## NOTICE TO ALL FIRMS

Date: March 24, 2025  
To: All Prospective Bidders  
From: Sam Li  
Interim Director of Procurement Services  
Re: Addendum Number 1  
IFB # C1595R – Alumni Hall Reroof

## PIPE OR CONDUIT SUPPORT

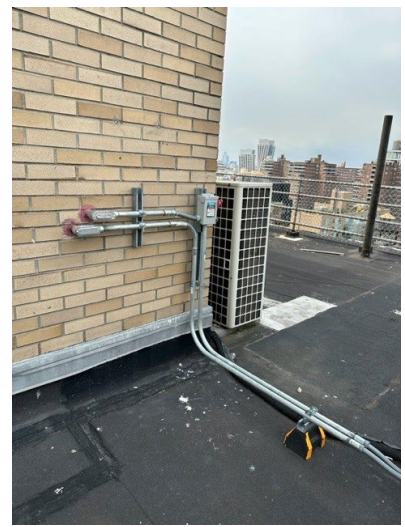
Q10. Keynote #22/A100.00 RELOCATE CONDUIT FROM FENCE TO RUBBER SUPPORTS ON TOP OF ROOFING. SEE DETAIL #10/A.801.00 FOR MORE INFORMATION (In given reference there is no detail for the rubber support)

A10. Keynote 22 specifically refers to rubberized pipe or conduit supports on the roofing system, which shall be reused. See A.100.00 for roof symbol legend and location of pipe or conduit supports. Detail #9 & #10/A.801.00 highlights the scope of conduit at the fence, which shall be relocated to the new guardrail as detailed. See Q11 for more information.

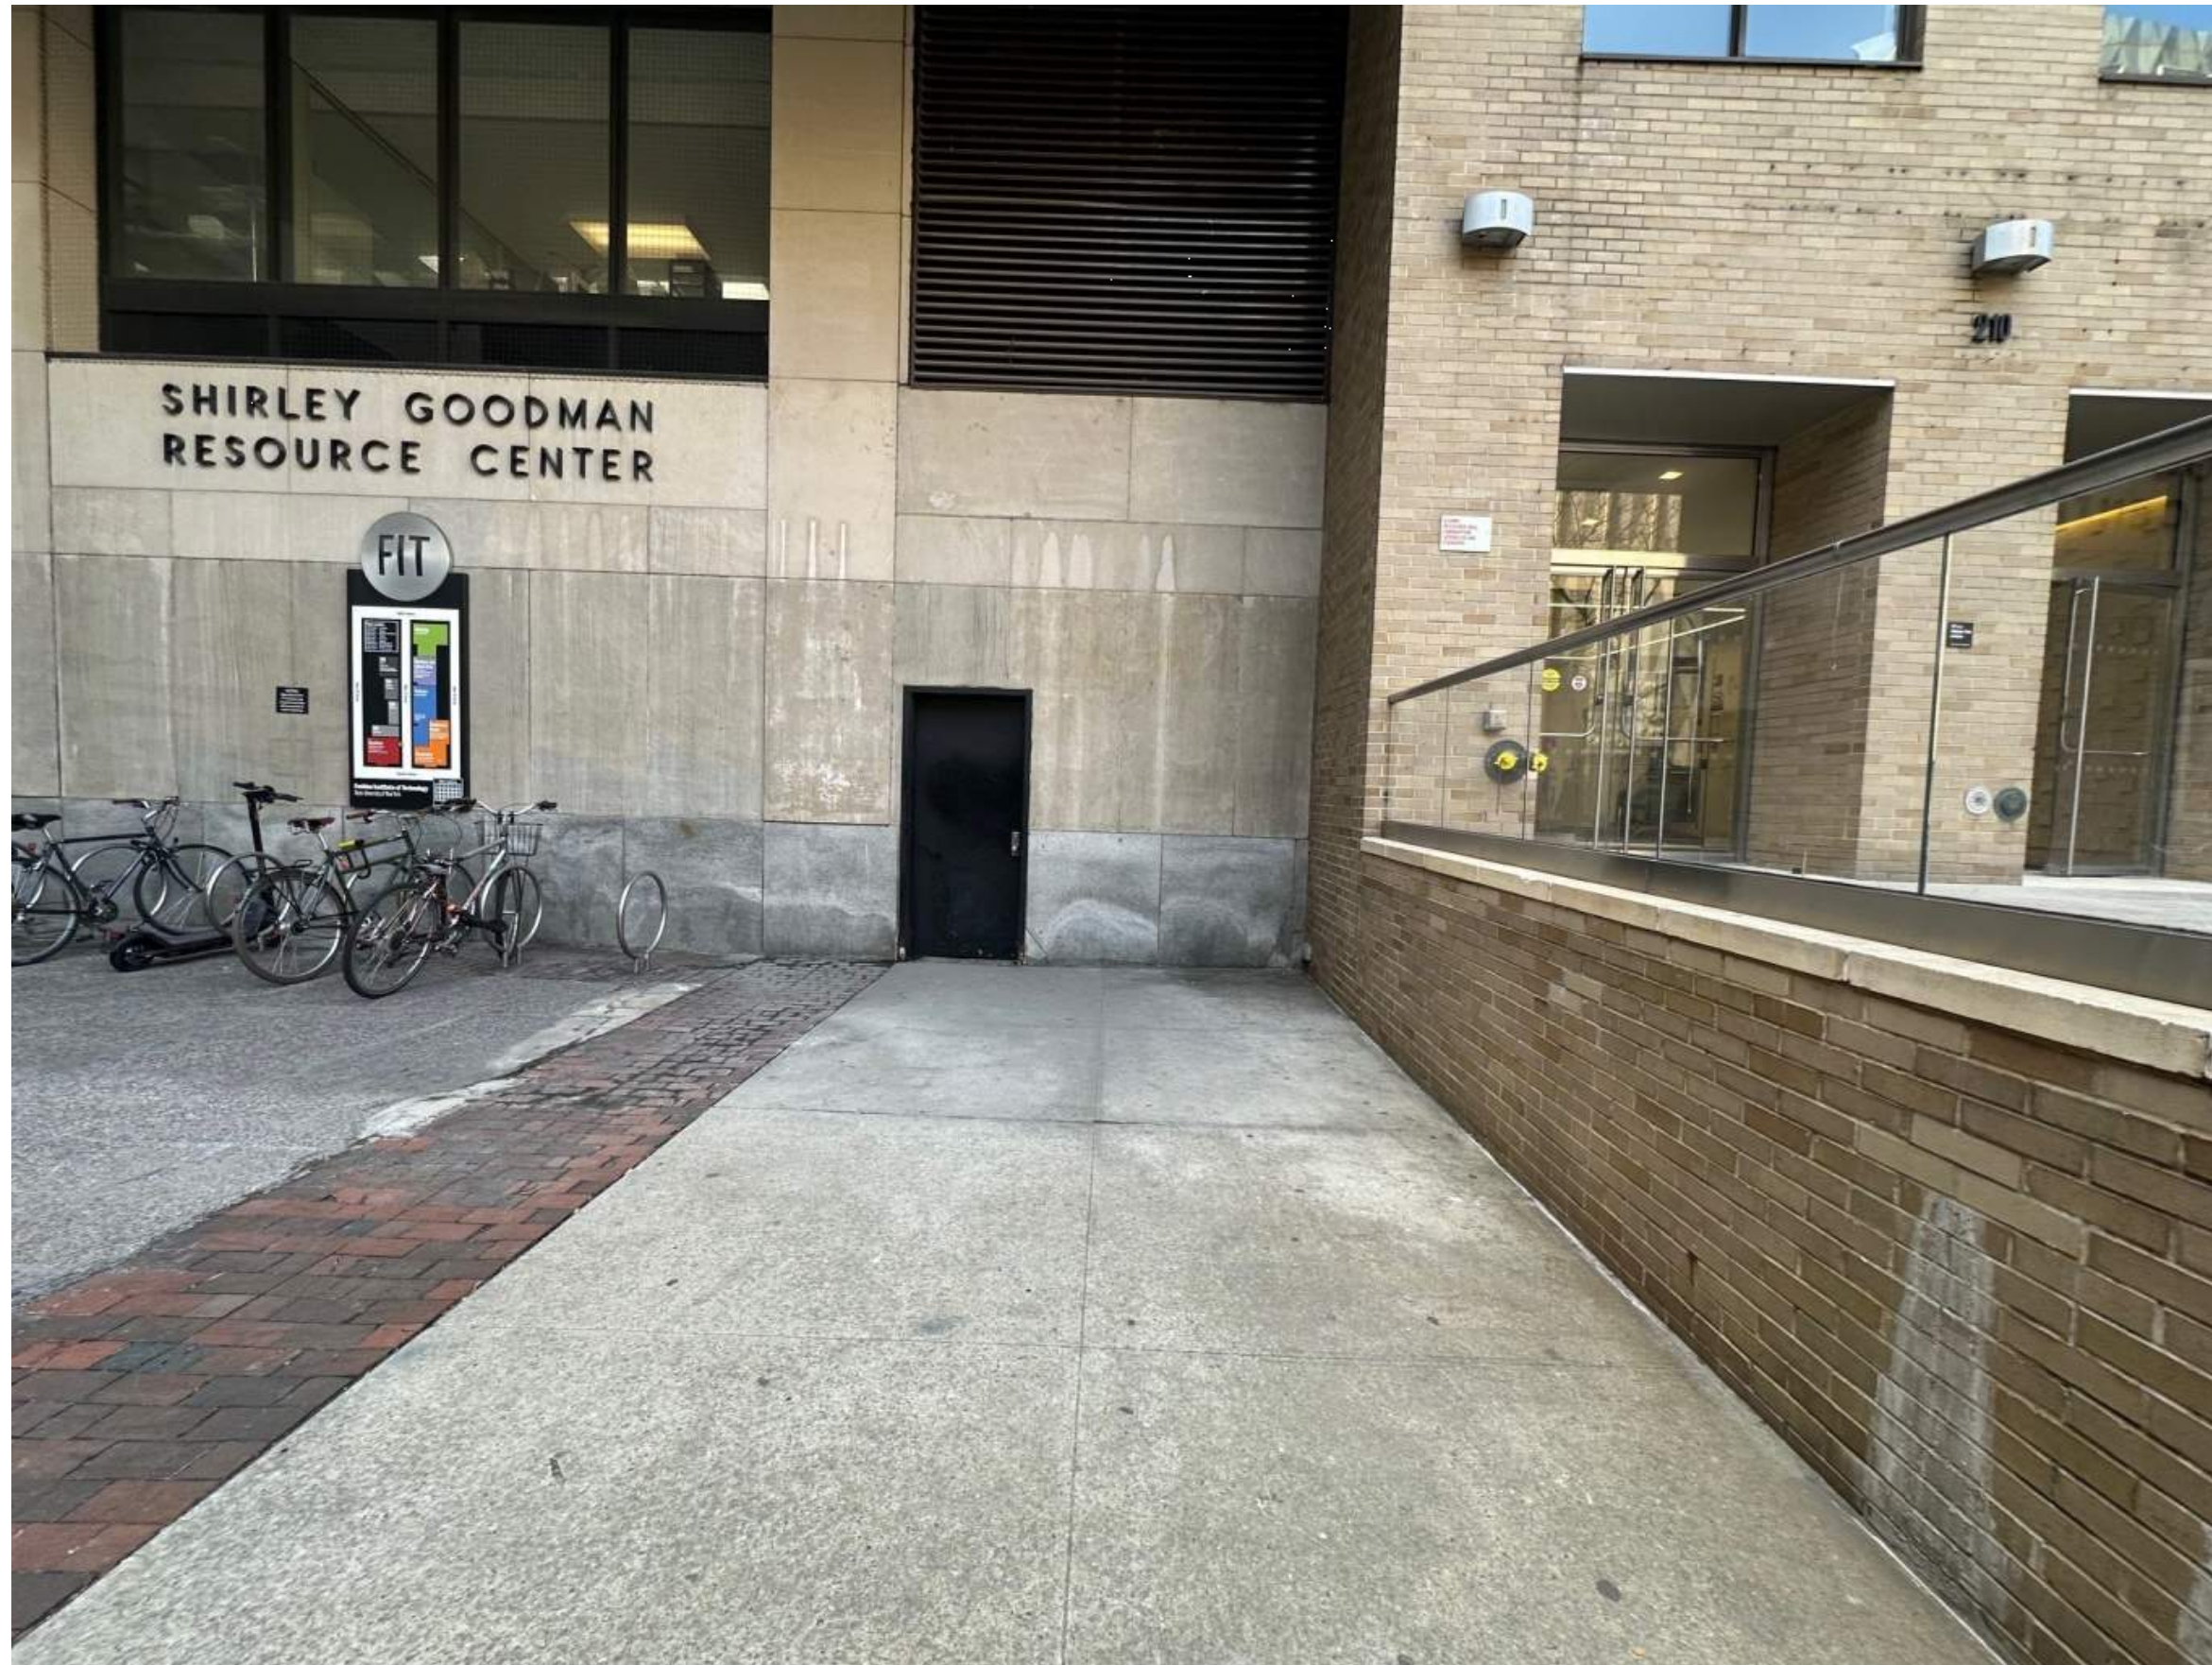
- Q1. There are some plants on the balcony that are not shown in the plans. I need to know what should be done with them- should they be removed, or do they need to be relocated and installed? They occupy a significant area of the roof.

- Q2. What area has been designated for staging?
- A2. Staging will be on east side of entry at 27<sup>th</sup> Street. Contractor shall maintain access to the black door and bike racks in front of Shirley Goodman Resource Center. See attachment for photo.

- NOTES:
1. FLOORS 1-17 WILL BE VACANT DURING CONSTRUCTION. TENANT WILL OCCUPY 18TH FLOOR.
  2. ELEVATOR ACCESS PROVIDED UP TO 17TH FLOOR FOR PERSONNEL ONLY.

3. STAIRS PROVIDES ACCESS TO THE ROOFS BEYOND 17TH FLOOR.
  4. SHED REQUIRED AT 27TH & 26TH STREET.
  5. STAGING AREA ONLY ACCEPTABLE ON 27TH STREET AND CONTRACTOR IS RESPONSIBLE FOR ALL MATERIAL STORED. CONTRACTOR MUST PROVIDE 10 FEET OF CLEARANCE TO GOODMAN FOR ACCESS TO BLACK DOOR & BIKE RACKS. (SEE PHOTO ON NEXT PAGE)

6. WORK INSIDE DORMITORIES AT 17TH FLOOR MUST BE COMPLETED BY JULY 15TH.
  7. AT 18TH FLOOR SOUTHERN TERRACE, ACCESS FROM THE FLOOR ABOVE. NOTE; CONTRACTOR MUST COMPLETE WATERPROOFING INCLUSIVE OF IRMA WATERPROOF LAYER, THROUGH-WALL FLASHING & PAVERS BY JULY 1ST TO HAND BACK SPACE TO 18TH FLOOR TENANT. PREMANUFACTURED COPING MAY BE INSTALLED LATER GIVEN TO LONGER PROCUREMENT TIMELINE. WORK WILL BE DONE DURING REGULAR BUSINESS HOURS.

8. AT 18TH FLOOR NORTHERN TERRACE, ACCESS WILL BE COORDINATED WITH THE OWNER AND THE WORK WILL BE DONE DURING REGULAR BUSINESS HOURS.
  9. REGULAR WORK HOURS ARE 7:00AM - 6:00PM. NO NOISY WORK PERMITTED BEFORE 9:00AM WITHOUT WRITTEN CONSENT FROM OWNER.
